UNITED STATES PATENT AND TRADEMARK OFFICE

APPLICATION NO.	FILING DATE	FIRST NAMED INVENTOR	ATTORNEY DOCKET NO.	CONFIRMATION NO.
10/539,189	06/22/2006	Richard Corbett	09728.0329USWO	2699
23552 7590 05/14/2009 MERCHANT & GOULD PC P.O. BOX 2903 MINNEAPOLIS, MN 55402-0903			EXAMINER DODD, RYAN P	
			ART UNIT 4134	PAPER NUMBER
			MAIL DATE 05/14/2009	DELIVERY MODE PAPER

Office Action Summary	Application No. 10/539,189	Applicant(s) CORBETT ET AL.	
	Examiner RYAN DODD	Art Unit 4134

DETAILED ACTION

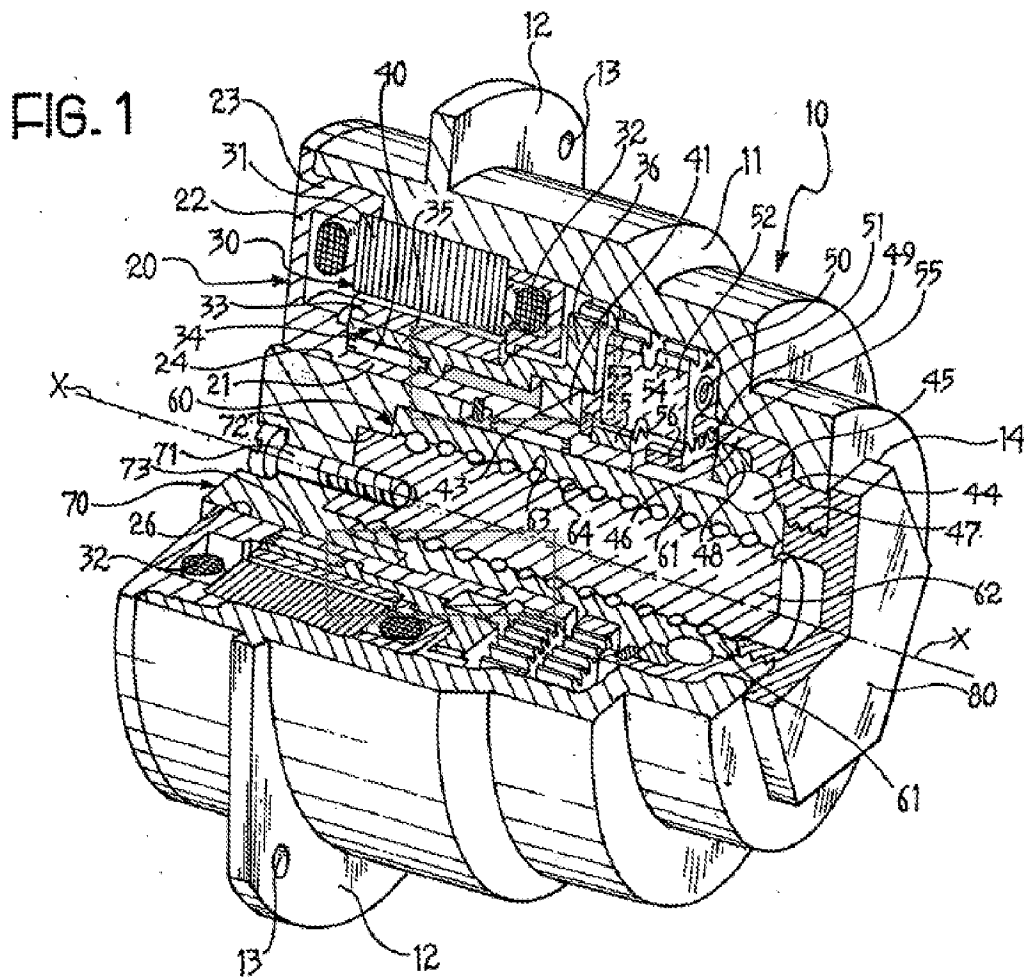
5. The drawings are objected to as failing to comply with 37 CFR 1.84(p)(4) because in figure 1, reference characters (55) and (56) both point to what is described as the output gear (56) in the specification (page 4, first paragraph). Reference character (55) is also used to refer to a fixed gear. It is proposed that applicant not point reference character (55) at the output gear in figure 1.

6. The drawings are objected to under 37 CFR 1.83(a). The drawings must show every feature of the invention specified in the claims. It is claimed in claim 1 that supporting element (21) externally, rotatably supports the rotor (34) of the electric motor (30). Figure 1 demonstrates an asymmetric approximation of this. The upper cross-section is not congruent to the bottom cross-section in many respects, and delineates a

space (shaded area), whereas the bottom does not.

Therefore, it is recommended that applicant at least correct Figure 3 and perhaps the lower cross-section of Figure 1, or else at least make reference in the specification to the most accurate rendition of the claimed subject matter, or cancel the features from the claim(s). No new matter should be entered.

FIG. 3

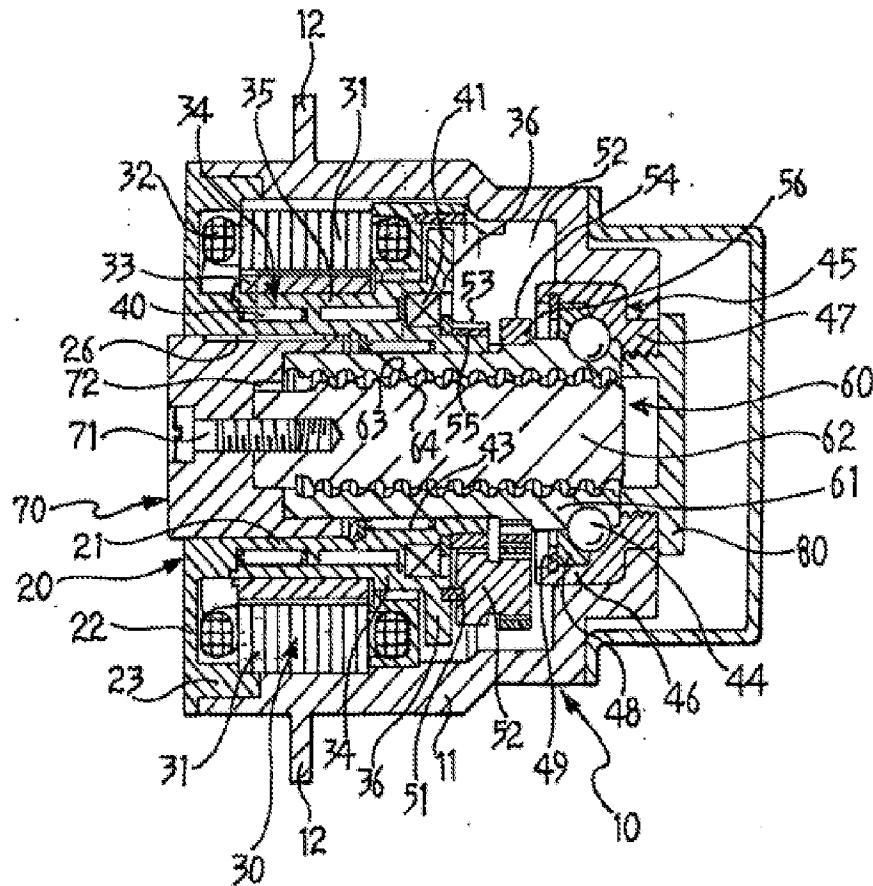
7. Figure 3 shows a symmetric rendition of the relationship between the supporting element and the rotor, but does not delineate a separating line between the two elements, suggesting to an observer that they may rotate as one element.

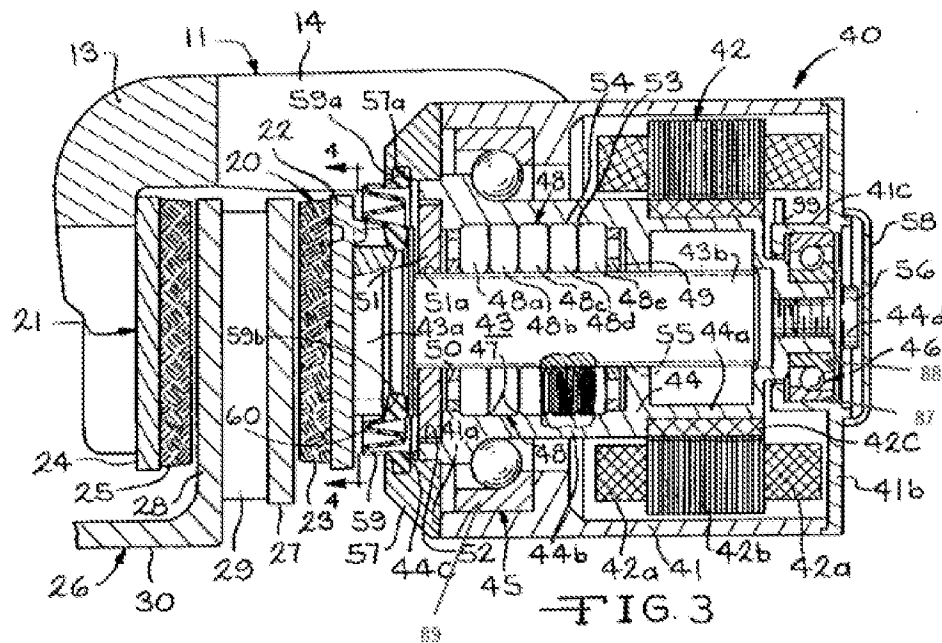
27. As to claim, 13, Hilzinger '552 discloses the actuator assembly according to claim 1, wherein the screw mechanism (ballscrew 60) includes a ballscrew.
